PRODUCT IMPROVEMENT BULLETIN

TITLE X+90 ADJUSTMENT POT					РІВ NO. DK3062
PRODUCT LINE.	TAPE TO THE TOTAL	EQUIPMEN 102811	T CHANGED PCBA \	MODEL SERIES AFFECTED D3000	EFFECTIVE DATE August 31, 1976
CLASS OF BULLETIN: [] IMPROVEMENT [] RETROFIT ON FAILURE [] RETROFIT RECOMMENDED [X] SERVICE INFORMATION ONLY		ORDER PAF KIT NO. N/A	PCBA - 102811, Rev. W	Rev. T through

TITLE X+90 ADJUSTMENT POT

PIB NO. DK3062

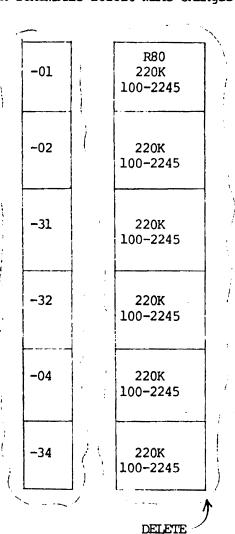
DRAWING CHANGED

On schematic 102810 make changes as follows, sheet 3, table 1.

102811-01 AB, 102811-02 Z, 102811-31C, 102811-32 C Add + ECN8360 to all versions
